# **Capillary rise quantification by field injection of artificial deuterium and laboratory soil characterization” by O. Grünberger et al.**

This document contains authors comments and actions to enhance the manuscript following the suggestions of the reviewers.

Authors answers to comments by referee # 1

Fig. 5. corrected figure 1

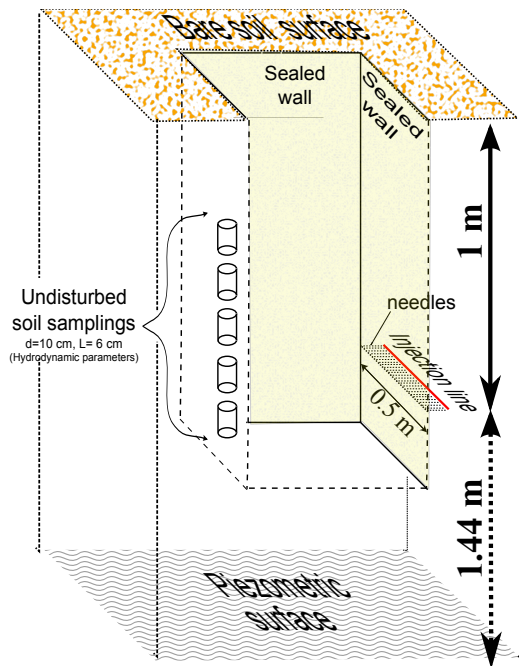
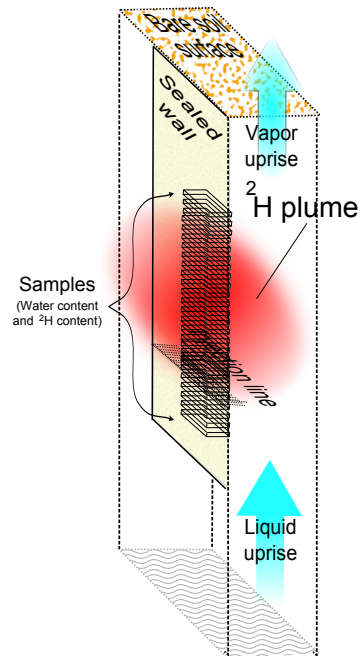
Reviewer #1 7764. 7775. fig 1: precisions on the dimensions of samples in right part

Authors agree : Samples where taken with a PVC tube of 6 cm of diameter and 10 cm length. We will add this information inside figure 1. (see New Fig 1 and P5 Lines 5-6)

Fig. 6. corrected figure 2

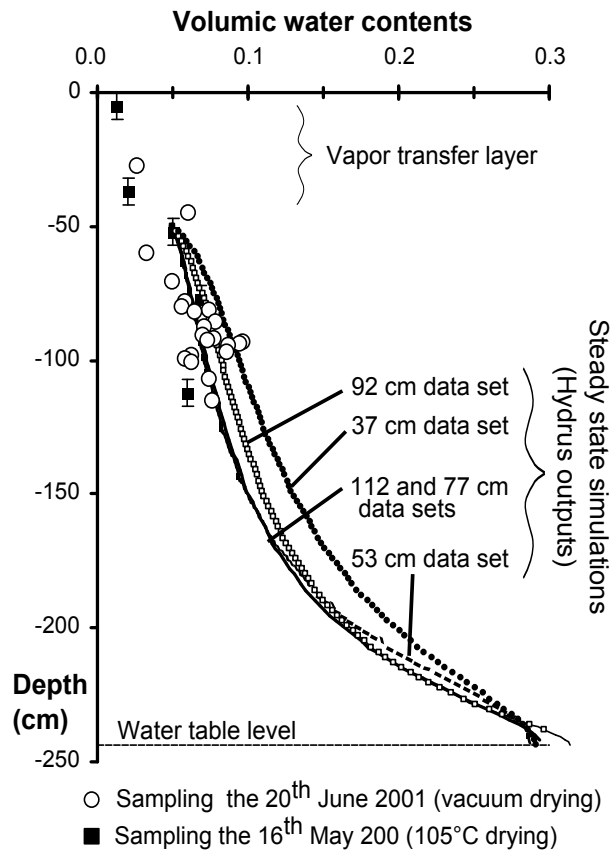
Reviewer #1 7776 Fig 2: need precision on the empty circles

Reviewer #2 : Where are the results from Hydrus simulations for shallow depths (<50cm) in Figure 2?

Reviewer #2 :The figures are useful though the captions need to be expanded. In figure 2. a legend is missing.

Authors comments: We agree. nevertheless. the size of the empty circles was chosen to be greater than the estimated accuracy of the measurements. We will add in the caption: the following sentence: “Estimated accuracy for sampling point was 0.5 cm in level and 0.5% in water content. ( P23 line 10-11)

We will introduce inside the figure 2 caption: As water contents were very low in the upper part of the profile (depth <50 cm), significant vapor transfer was suspected. Consequently, top layer of the profile was not considered in the simulation.( P23 line 8-9).

Authors' answer : We agree and we input new captions in the legend in fig 2. ( See new figure 2)

Fig. 7. new figure 5

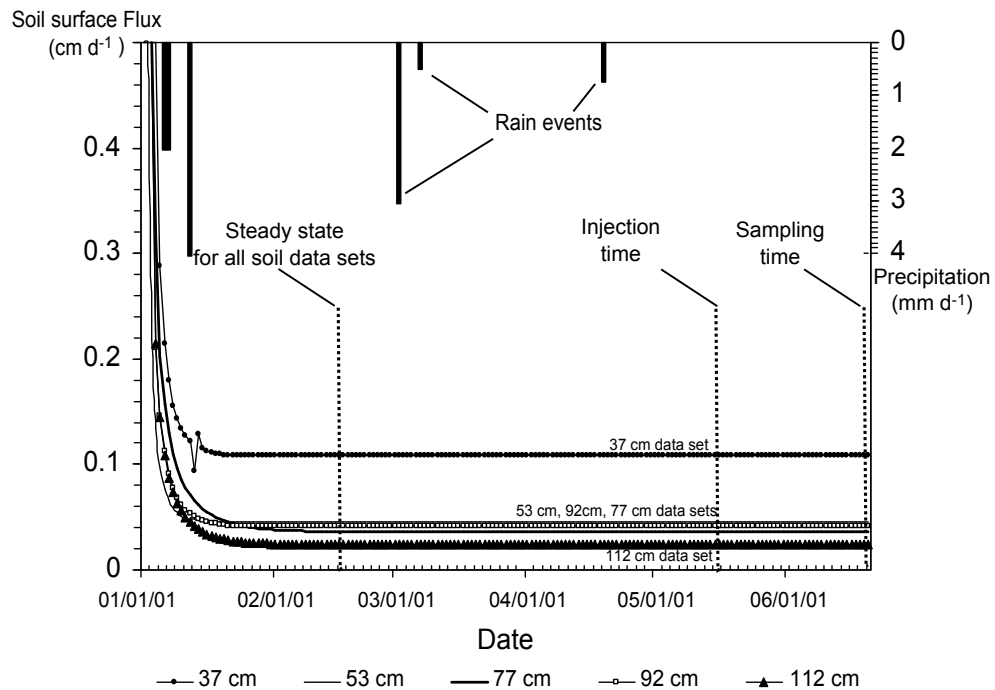
Reviewer #2 The authors do not convince the reader that the system was at steady state over the course of the experiment nor do they provide an assessment of the impact on the results if the steady-state assumption was violated.

0.0495%. Water content at 50 cm depth. assuming ET and Rainfall events measured at Agadir Meteo station d. What ever was the soil parameter data set introduced in the model, permanent steady state is installed in no more than 50 days after saturation. (Injection is performed the 135th days of the year) (see following graph for illustration)

Figure 5: Simulation of the steady state establishment for 5 different van Genuchten soil parameters sets, assuming an initial saturation of soil profile from 0.50 m to 2.44 m at the beginning of the year 2001. Uprising fluxes computed with Hydrus 1D (right axis, cm d-1) and rain events (left axis, mm d-1). Boundary conditions reflecting: i) meteorological data (rain events and potential evaporation (5 mm d-1)) and maximum suction head corresponding to 0.0495 water content at the upper cell (0.5 m depth), ii) Lower boundary condition fixed to water saturation at 2.44 m depth. The top layer (0 to 0.5m depth) was not considered in the simulation.
